Some video cameras may not work with the 5.8GHz 100mW A/V transmitter. That is, you may find that you have good sound, but the video image is missing. This addendum provides instructions on how to change the video input on the transmitter so that it provides a fully compatible 75Ω DC termination to the camera's video signal.

This addendum only applies to the Rev-B and Rev-C AV681TX kits. We recommend that this update be used during initial assembly. If yours is already built and working well, then you may ignore this addendum. But please keep it in mind if you experience camera compatibility issues later on.

Title: 5.8Ghz TX KIT			www.dpcav.com	DPC AV AUDIO VIDEO
Size: Letter	AV-681TX	Revision: C1		
Date: FEB-11-2009		Sheet 1 of 1		
Copyright: 2008-2009

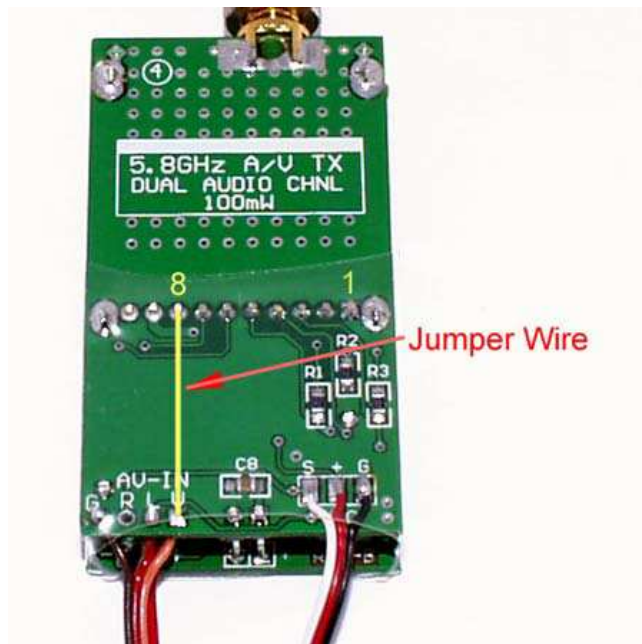
- 2.1 Use a fine piece of insulated wire and jumper the (+) and (-) ends of cap C5 (330uF). The most convenient way to do this is to add the jumper wire shown in the drawing below.

The jumper wire shown above bridges the video input (Pin-8) of the RF module to the transmitter's AV-IN "V" video input pad. This is the same as adding a jumper wire directly across cap C5.

AIRWAVE AWM681 TX

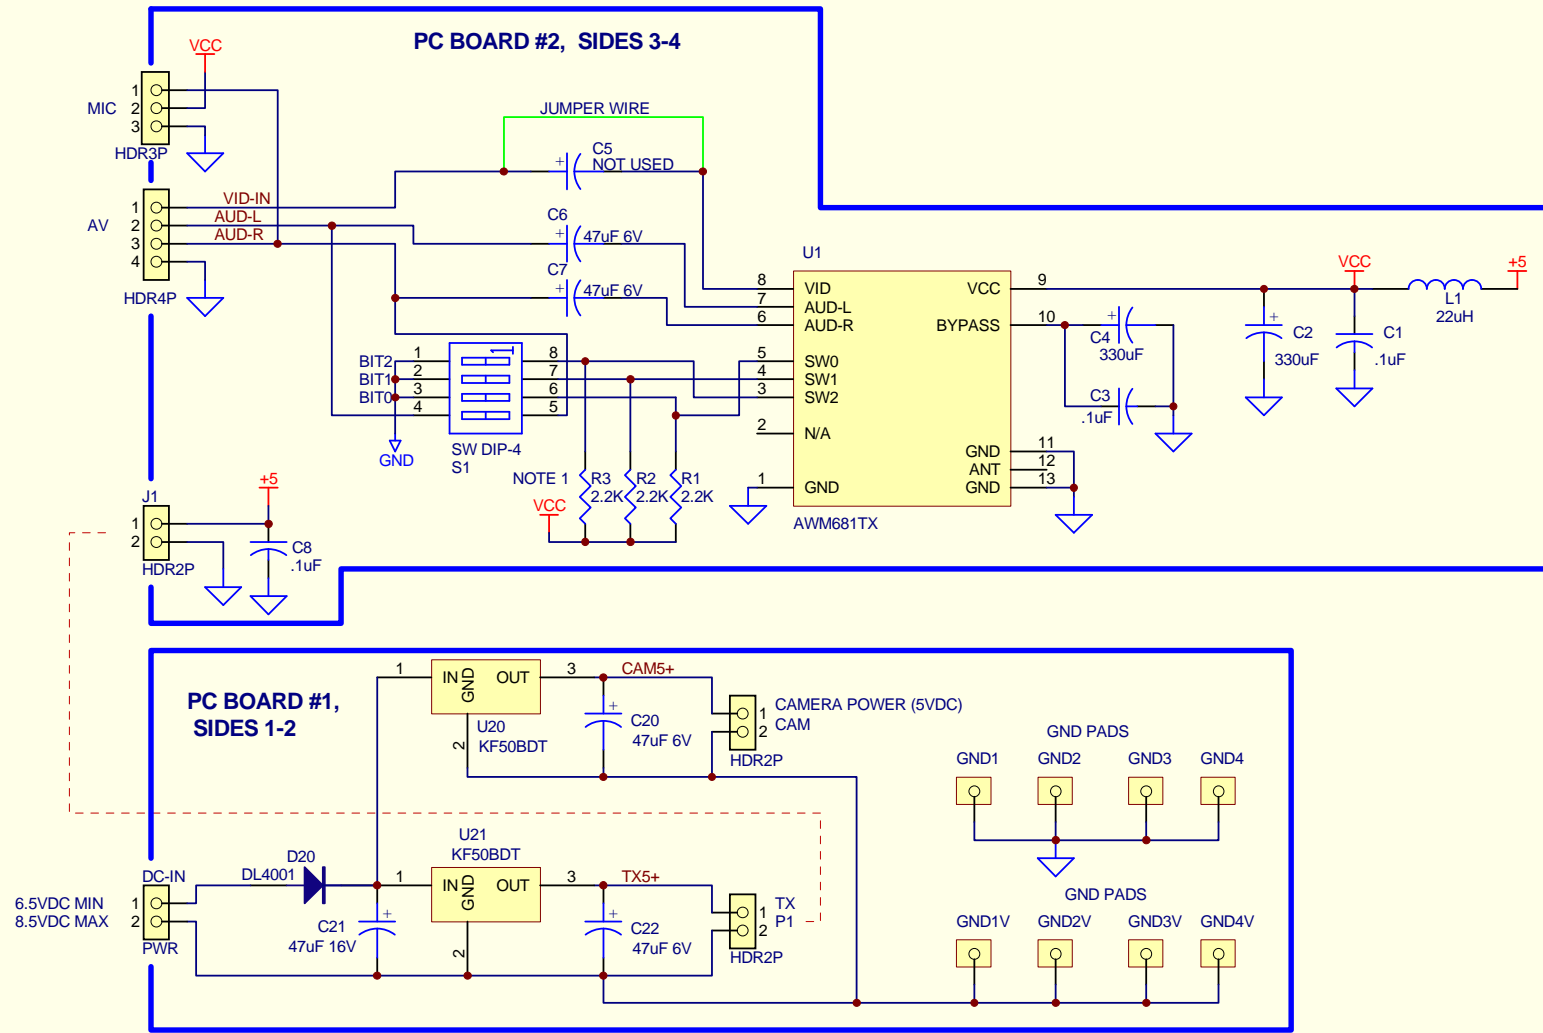
1 CIRCUIT CHANGE, UNASSEMBLED KITS:

- 1.1 Do not stuff capacitor C5 (330uF).
- 1.2 Use a fine piece of wire and jumper the two SMD pads at the C5 location.

2 CIRCUIT CHANGE, ASSEMBLED KITS:
